STAR ONLINE PUBLICATION

Case Number: S2108000205 Rev. A

Symptom/Vehicle Issue: Mopar Trailer Tow Module Kit Sales Incorrect Sales Code And/Or CAN IHS Wiring Incorrect Connector Cavities

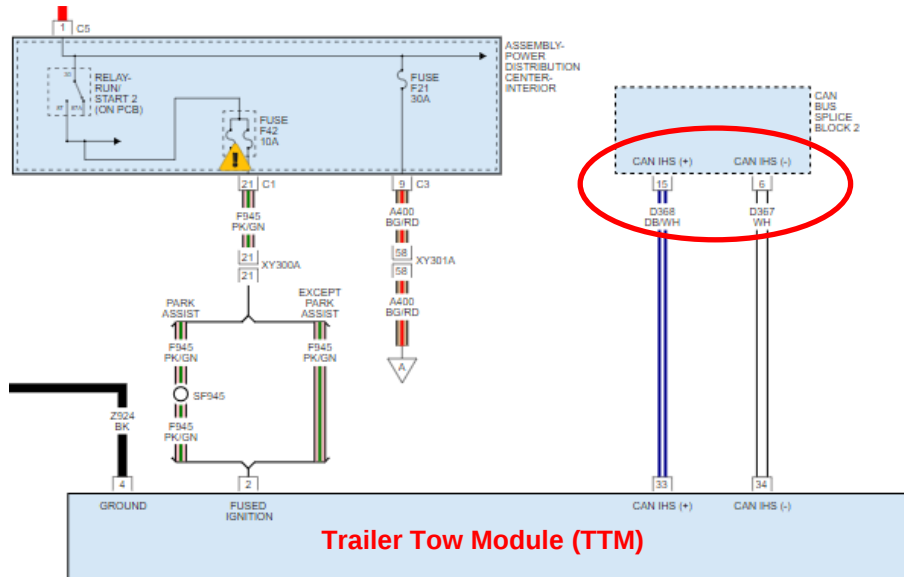
Discussion: The trailer tow features may be unavailable after installing the Mopar Trailer Tow Kit. The instructions provided may have had the incorrect sales code listed. The instructions may also have the incorrect terminals listed for the CAN IHS splice block.

Confirm the CAN IHS wiring from the TTM to the CAN Bus Splice Block 2 is correct.

CAN IHS (+) D368 DB/WH should be in cavity 15.

CAN IHS (-) D367 WH should be in cavity 6.

CAN IHS Wiring

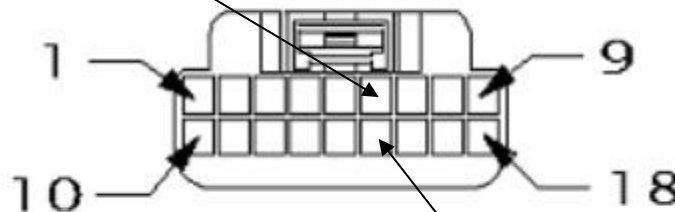
D367 WH

D368 DB/WH

Once the correct sales code is added and the TTM CAN IHS wiring corrected. Perform a Restore Vehicle Configuration using Witech. Cycle the ignition off and allow the vehicle to go to sleep. Cycle the ignition back on. The Trailer Tow system should now be operational.
